A. **MISTY MEADOW**: The request is to create 8 lots from Tax Parcel A14, created by Waiver Resolution #76-19-PWm, recorded as 79-258w, to be known as **MISTY MEADOW**, containing 10.5 acres +/- . The petitioner is requesting a variance from MSB 43.20.060(D). The property is located north of W. Hawk Lane, south of W. Delroy Road, and directly west of W. Parks Highway (Tax ID #17N03W02A014); within the NE ¼ Section 02, Township 17 North, Range 03 West, Seward Meridian, Alaska. In the City of Houston and in Assembly District #7. (Petitioner/Owner: Mosquito Park LLC, Staff: Matthew Goddard, Case # 2024-003)

B. **BOGARD COLONIAL MSP**: The request is to create 58 lots by a four phase master plan from Tax Parcel B20, created by Warranty Deed recorded at 2010-013191-0, to be known as **BOGARD COLONIAL MSP**, containing 33.71 acres +/- . The property is located east of N. 49<sup>th</sup> State Street, north of E. Palmer-Wasilla Highway, and directly south of W. Bogard Road(Tax ID # 18N01E36B020); within the NW ¼ Section 36, Township 18 North, Range 01 East, Seward Meridian, Alaska. In the Gateway Community Council and in Assembly District #2. **This case was continued from the April 4, 2

DRAWN BY ICAD/K.Lyne	DATE 8/16/23	DRAWING: 2023-9/MistyMeadows
CHECKED BY Glo	SCALE 1 INCH = 50 FEET	SHEET 1 OF 1

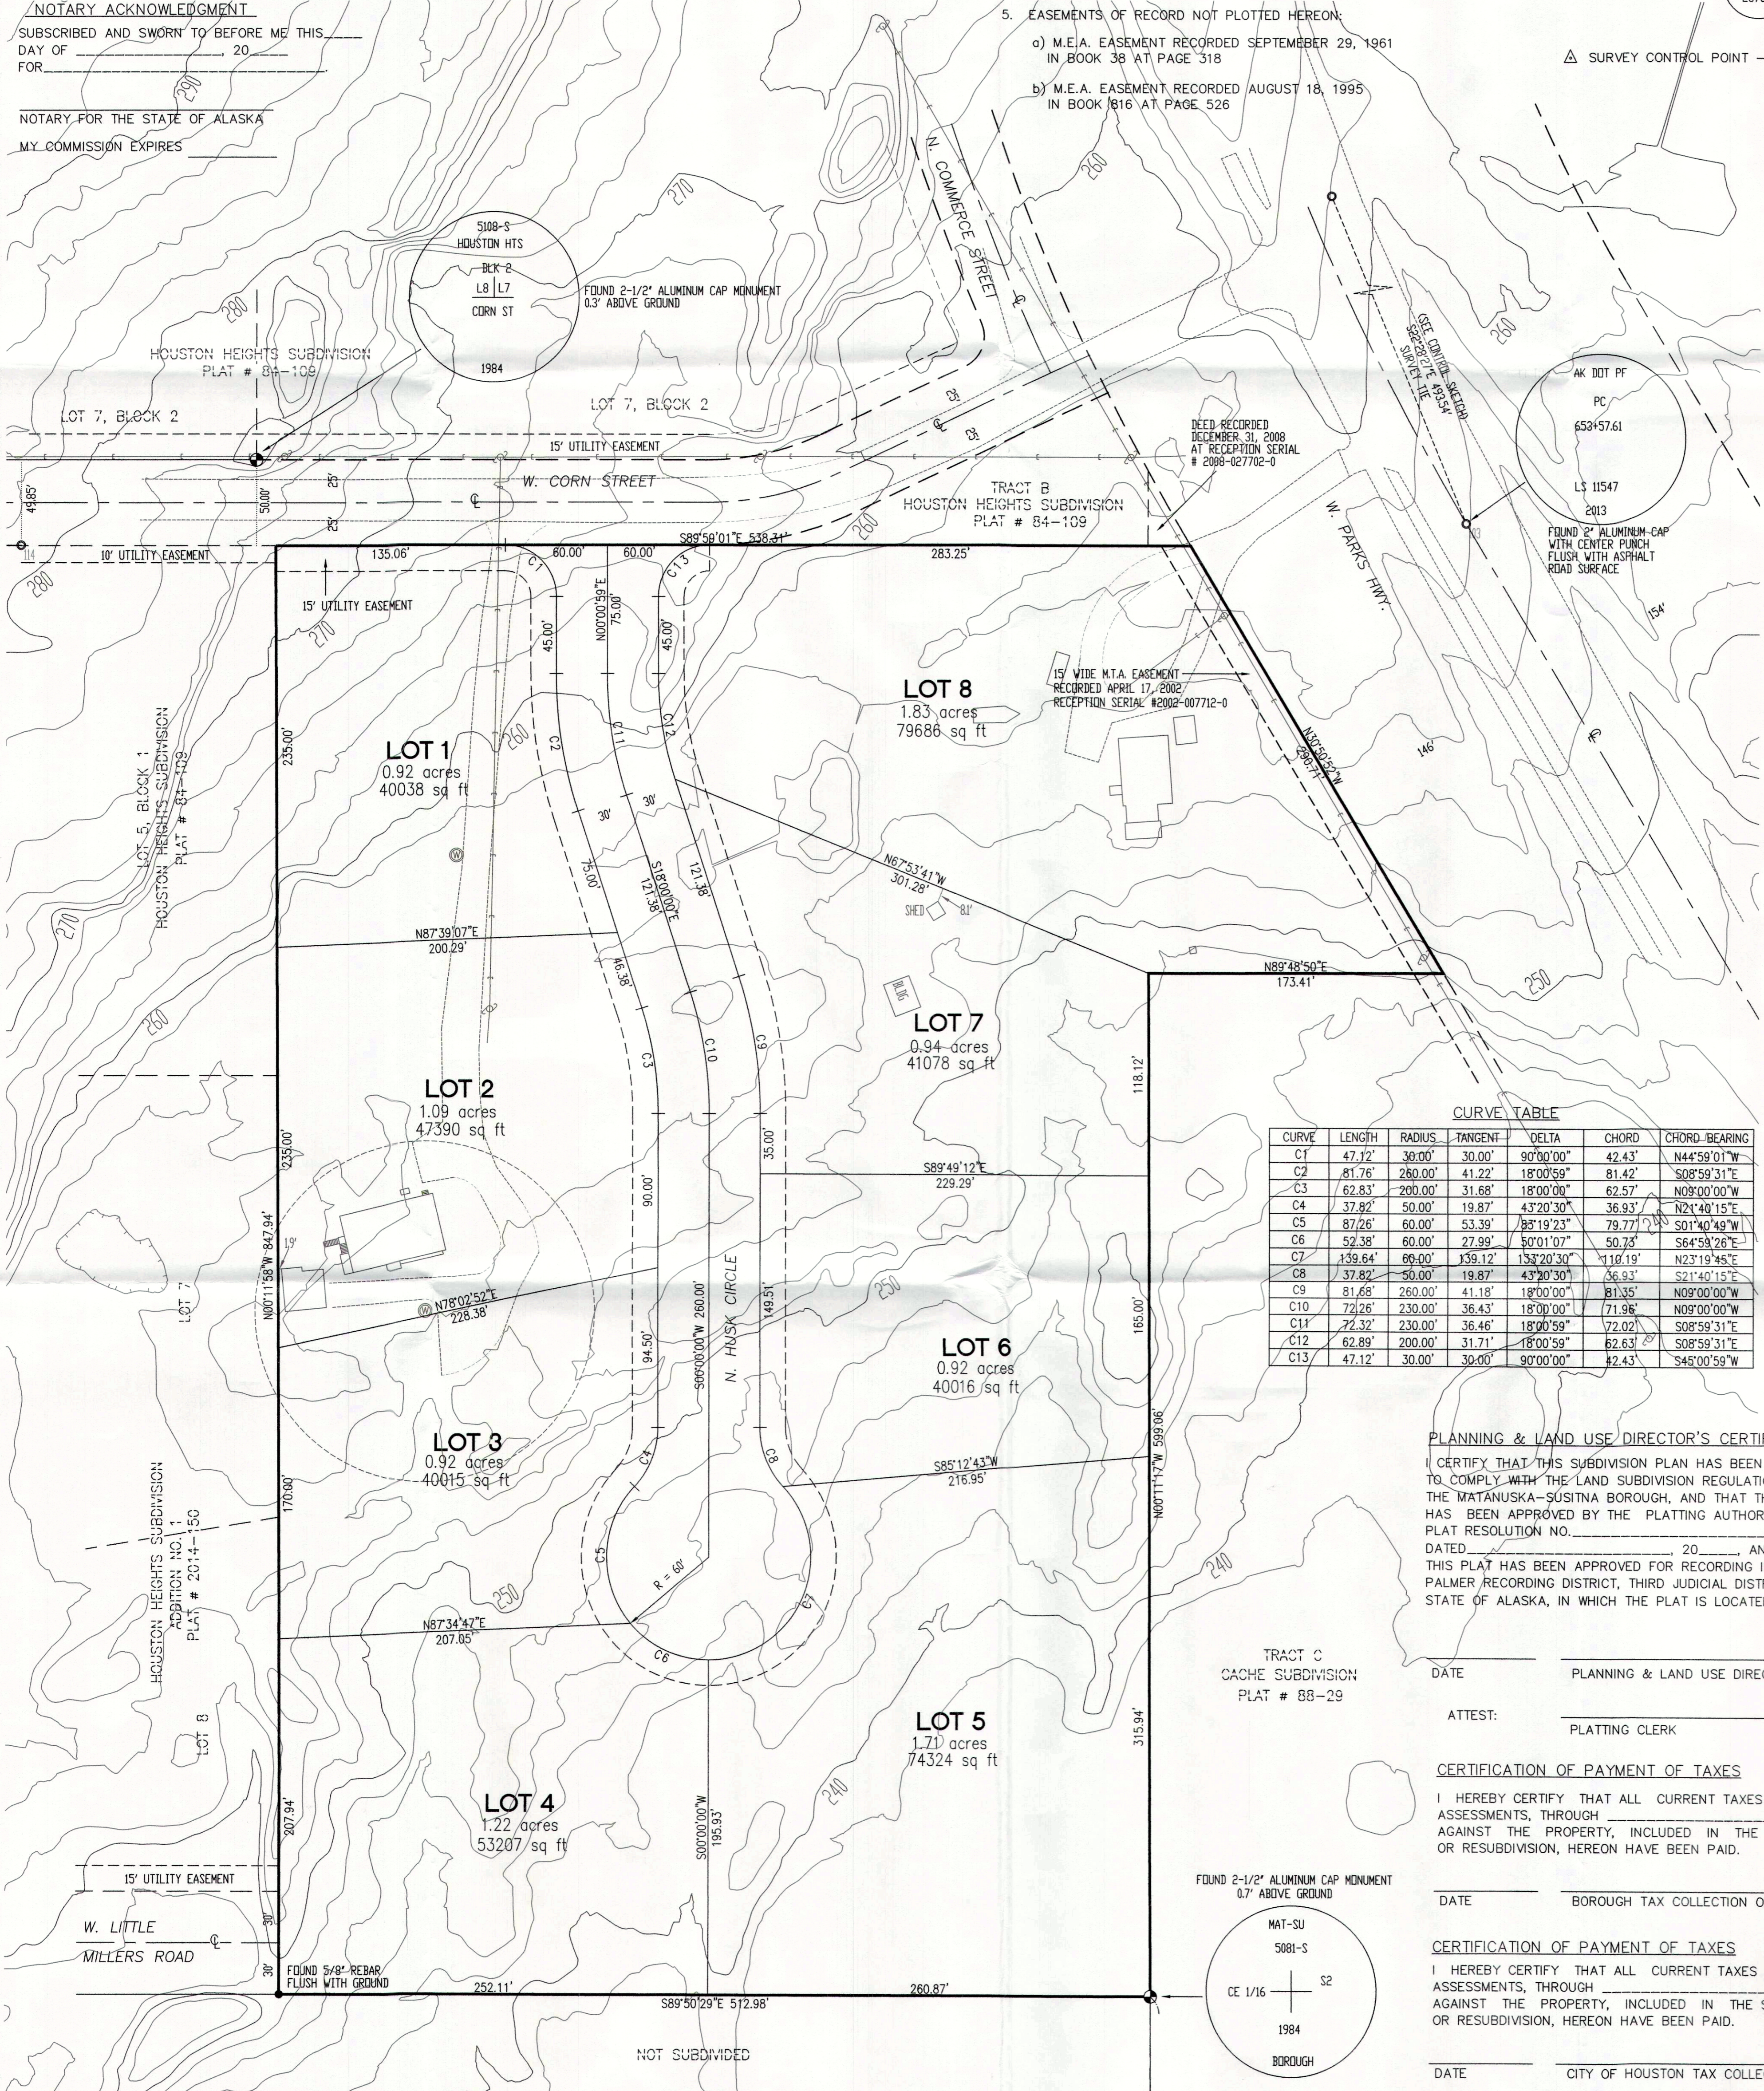
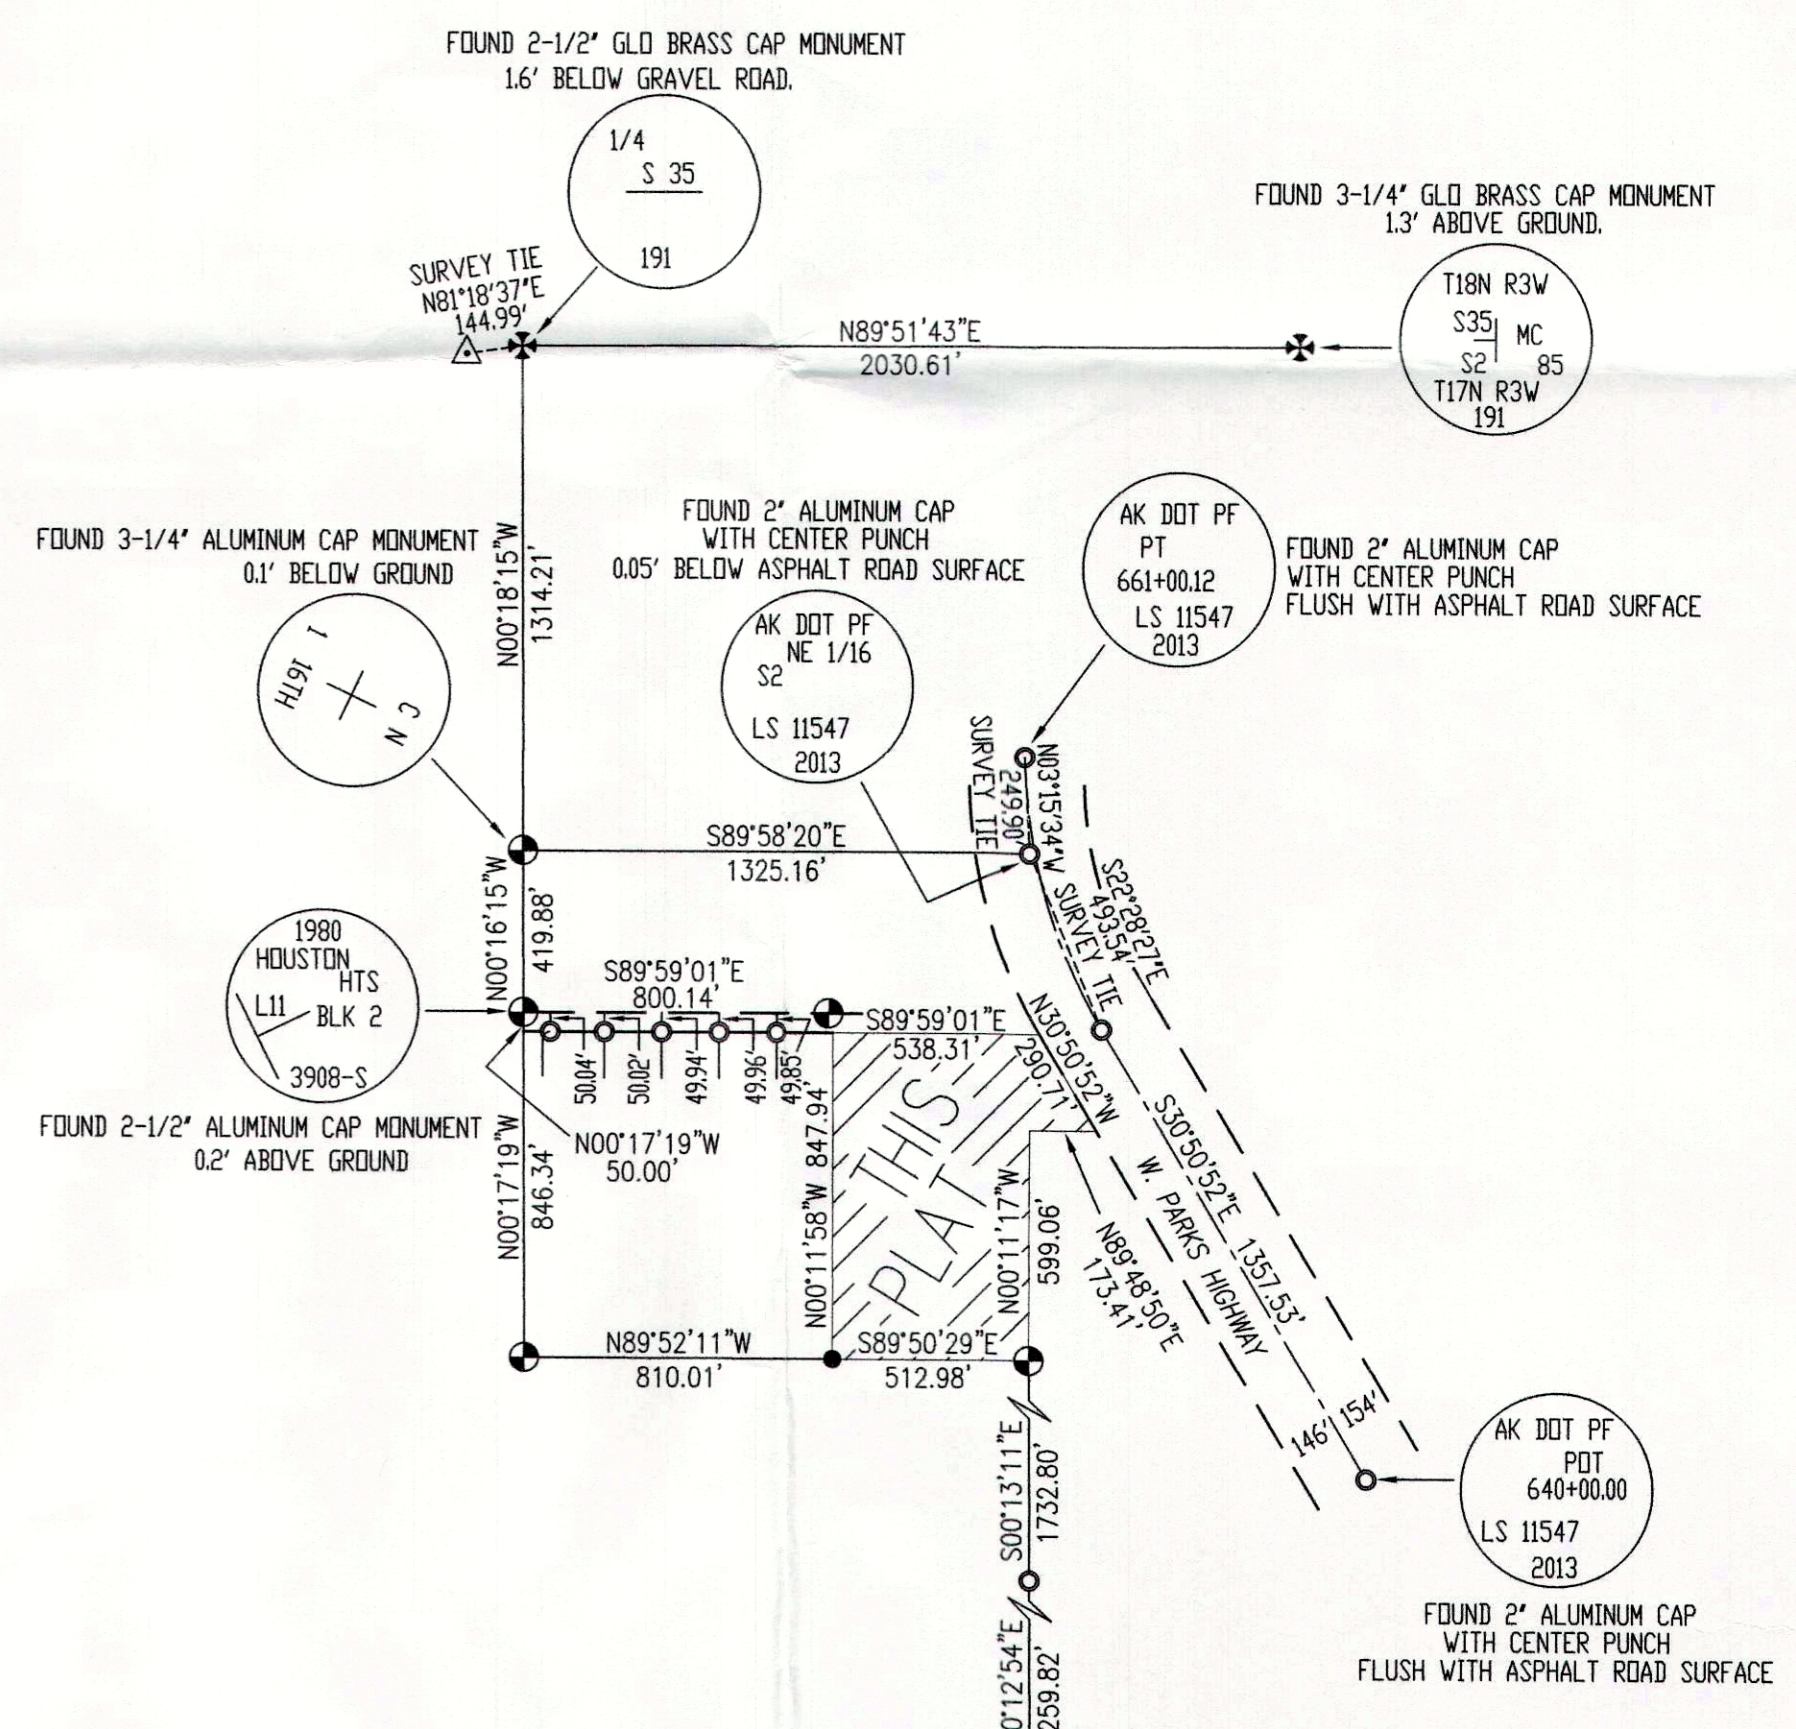
In review GCI has no objections only the following comment for the attached signed plat.  
The legal description in the location block needs to show the Township to be 17N.

REFERENCE NUMBER:  
C-1.0  
SHEET 1 OF 12

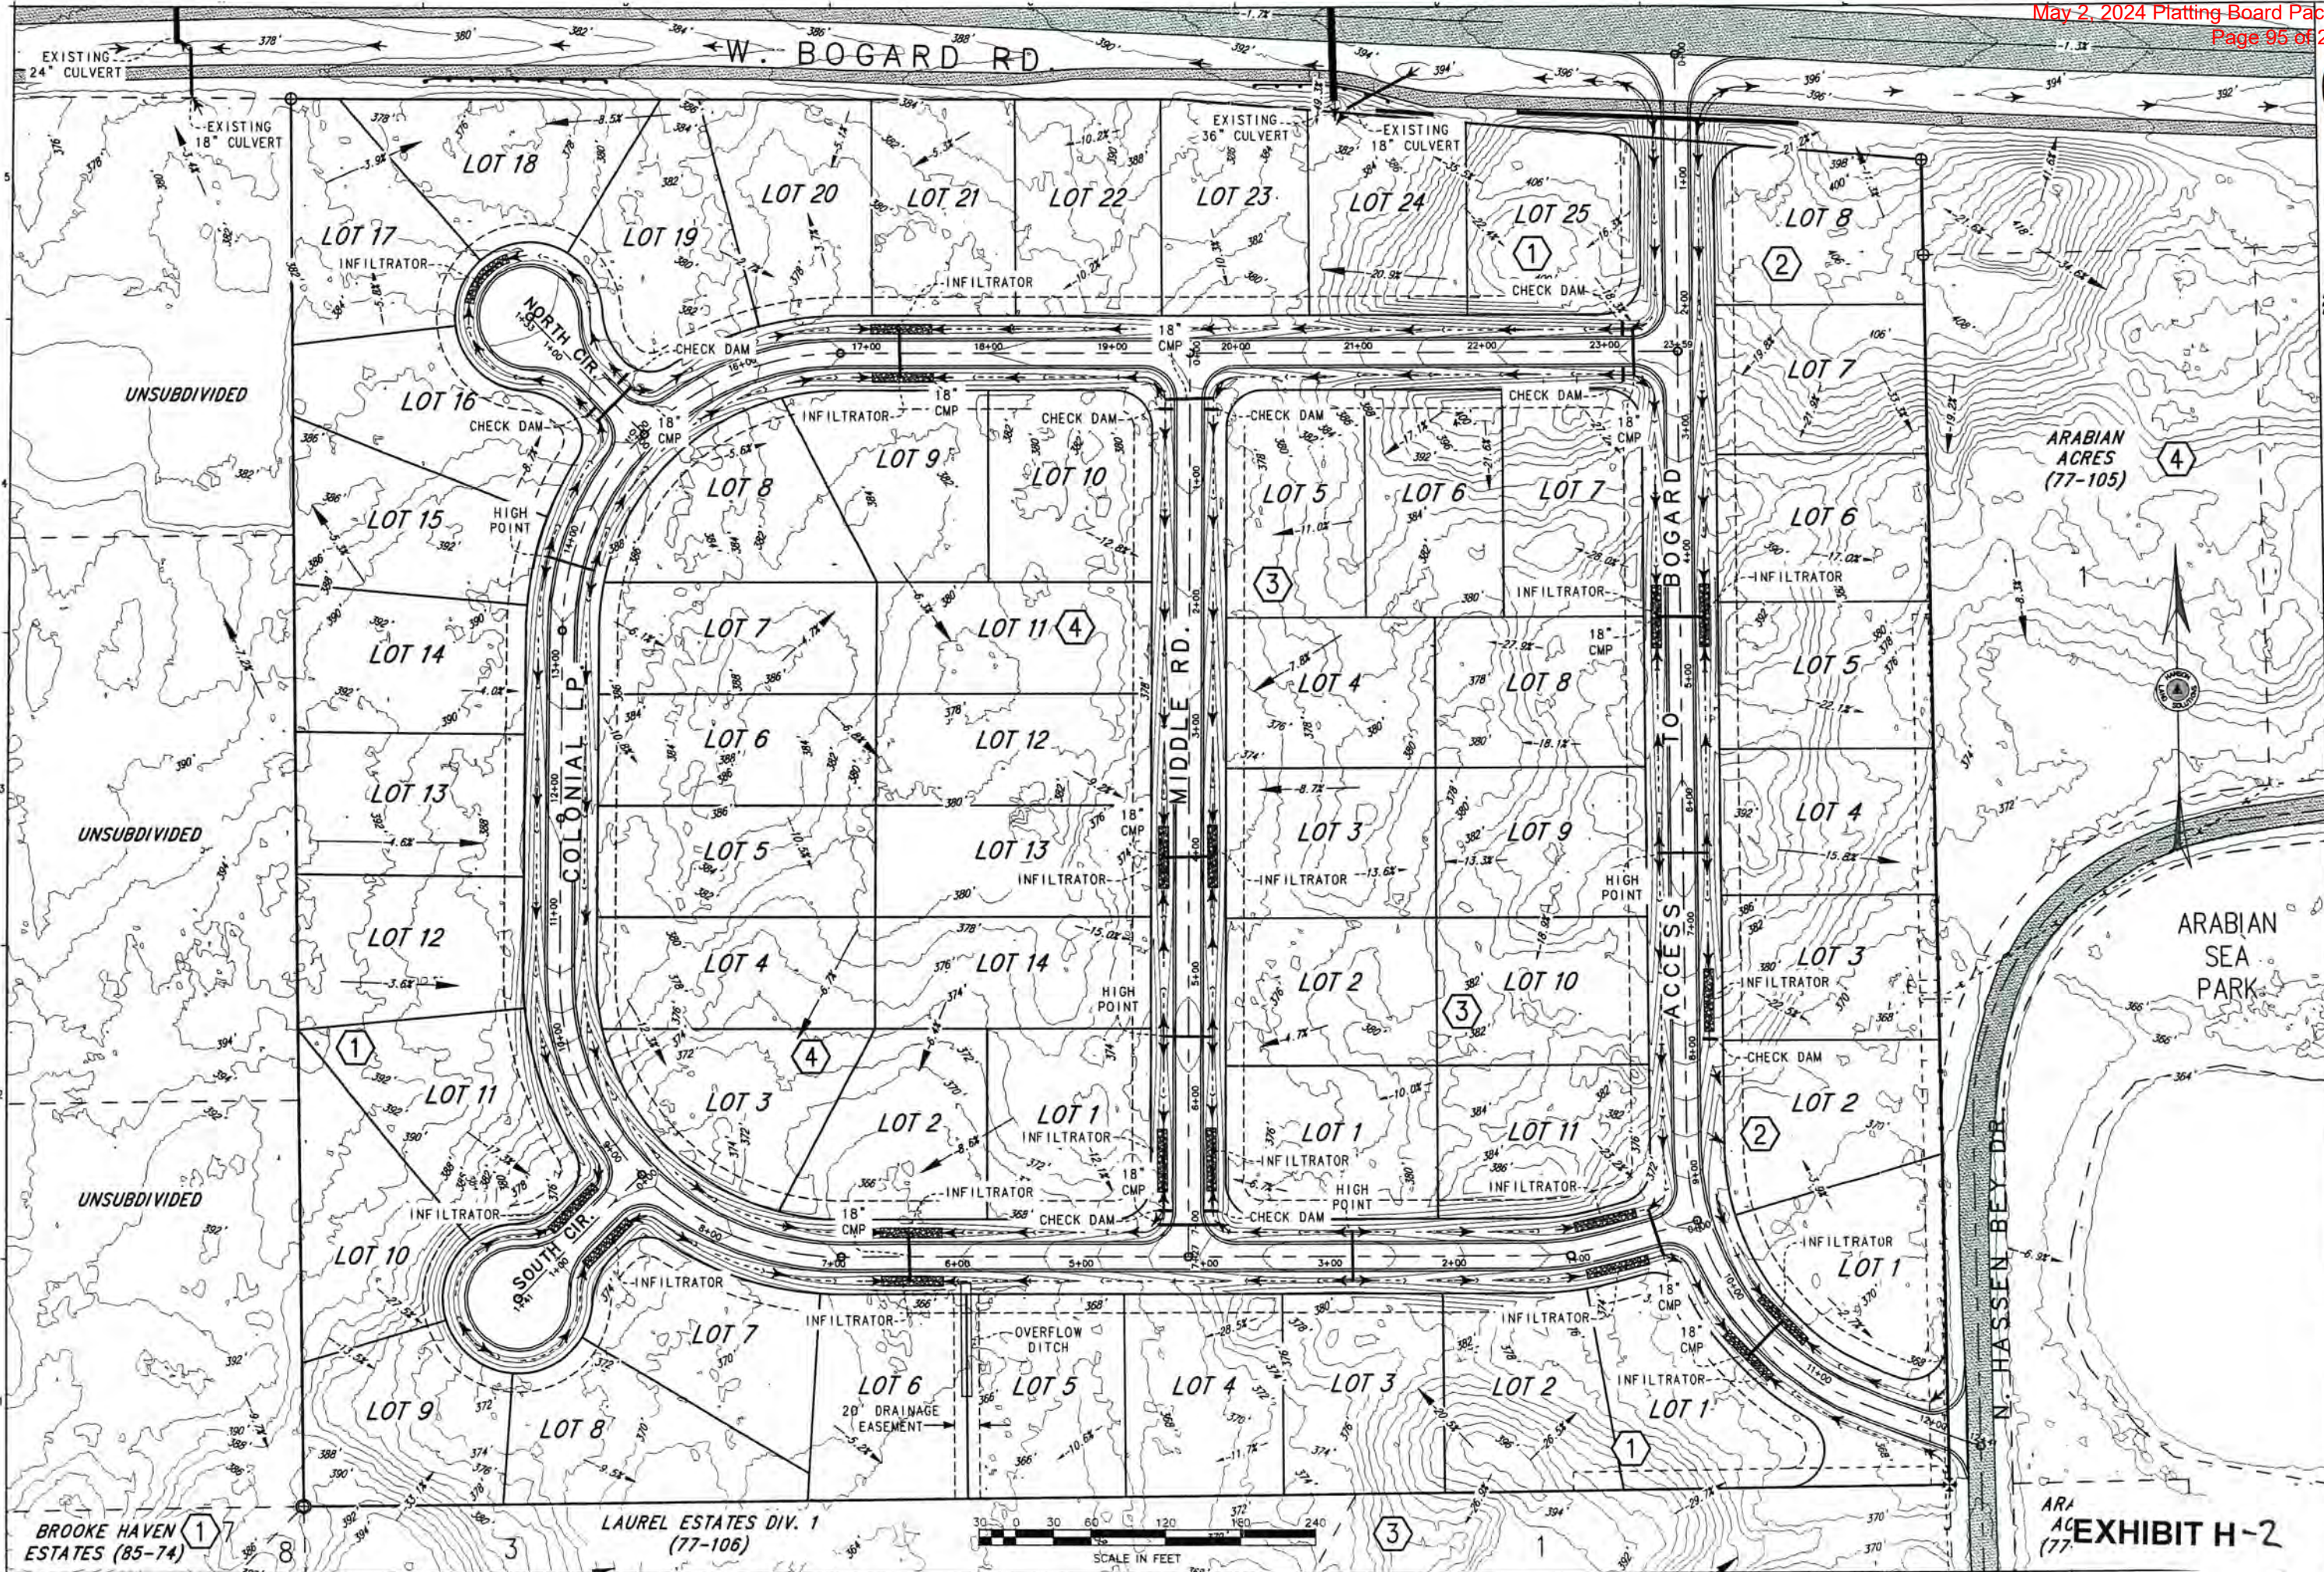
- Provide construction/demolition plans for the existing retaining wall adjacent to the Bogard Road right-of-way prior to the preconstruction conference. Include proposed grading details around the subdivision access road onto Bogard Road in the construction/demolition plans (**Recommendation 7c**).

- Within the clear zone of Bogard Road, foreslopes of the access road should be no steeper than 6:1 (**Recommendation #7**).
- Sweep Bogard Road pathway in at the intersection with the access road per Alaska Standard Plan (**Recommendation #7**).

- Provide drainage retention area outside of MSB ROW (**Recommendation 7g**). Based on past MSB Public Works experience, infiltration ditches do not provide long term water storage and infiltration. Rather, infiltration ditches have a history of filling in with fines, resulting in far slower percolation rates and saturation of the road embankment. Once the fines have clogged the infiltration ditch, they are difficult to maintain and often require ditch reconstruction.

- Show how area with reduced ditch depth and 1.5:1 backslope fronting Lot 8 and Lot 25 meets snow storage requirements of SCM Section D04.
- Provide drainage easements across Lots 23 and 24 to facilitate flow coming from Bogard Road culvert located north of Lots 23 and 24 and reaching the area of detention (**Recommendation 7h**). *Platting staff notes that DPW's comments/recommendations will be resolved during the preconstruction conference as noted at **Recommendation #7**.*

7. Construct internal roads and cul-de-sacs to residential street standards according to the 2022 Subdivision Construction Manual (SCM):
  - a) Submit drainage report and other construction plans to Department of Public Works (DPW) per SCM F01.2;
